To: Brent Damman - Building & Zoning  
Administrator  
From: Adam C. Hoff, P.E. - City Engineer *ACH*  
cc: Jon Bisher, Tony Cotter, Jeff Marihugh  
Date: January 10, 2000  
Subject: Kidz Kingdom - Site Plan Review

Re: Kidz Kingdom Site Plan

Re: City of Napoleon  
Kidz Kingdom Site Plan Review

*To: Brent Damman - Zoning Administrator*  
*From: Adam C. Hoff, P.E. - City Engineer* *ACH*  
*cc: Jon Bisher, Tony Cotter, Jeff Marihugh*  
*Date: November 8, 1999*  
*Subject: Kidz Kingdom - Plan Review*

① WOOD FIBER - 16" PROFILE

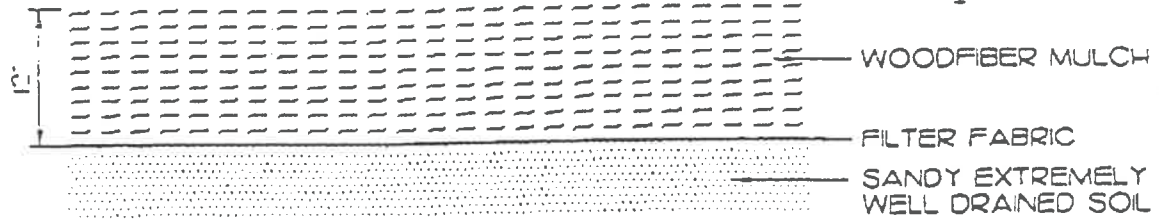
I have reviewed the site plan presented to the City for the proposed Kidz Kingdom complex and have some concerns regarding the drainage system, or lack thereof, for the proposed facility. The specifications for the proposed facility require that a drainage layer be provided and state that "The drainage system beneath the wood fiber varies depending upon your specific situation." The specifications further state that "The wood fiber must be separated from the drainage layer and the drainage layer must be separated from the existing ground by geotextile fabric." The site plan provided does not have a cross-sectional view of the facility showing any drainage layer, only a reference to sixteen (16) inches of wood fiber.

Additionally, it is unclear from the site plan as to whether the area for the proposed facility is to be excavated below the existing grade of the proposed site or if the facility will be placed on the surface. If the area is to be excavated, subsurface drainage (i.e. - perforated tile) will also be required as the soils at the proposed site are heavy clays and rain water that leaches through the wood chips will not dissipate quickly. In essence, any excavation would act very much like a pond without some form of subsurface drainage.

Based upon my review of the preliminary plans submitted for the referenced project, it is my recommendation that details for site drainage and under drains need to be provided prior to the approval of the plan. As currently proposed, it appears that the plan requires excavation for the placement of sixteen (16) inches of wood chips. As the proposed site has primarily heavy clay soils, I am concerned that the excavated area will retain water causing the proposed wood chips to decompose. It is my recommendation that the excavated areas be sloped to an underdrain system and overlaid with at least six (6) inches of stone beneath the wood chips.

In response to your December 27, 1999 letter requesting additional information on the drainage system for the proposed playground complex, a cross section detailing the drainage system is enclosed. Detail 1 on the enclosure shows the cross section for Kidz Kingdom. The detail shows that a filter fabric will be placed on existing grade. No excavation is planned. Above the filter fabric is a four-inch layer of gravel, another layer of filter fabric and then the sixteen inches of woodfiber mulch.
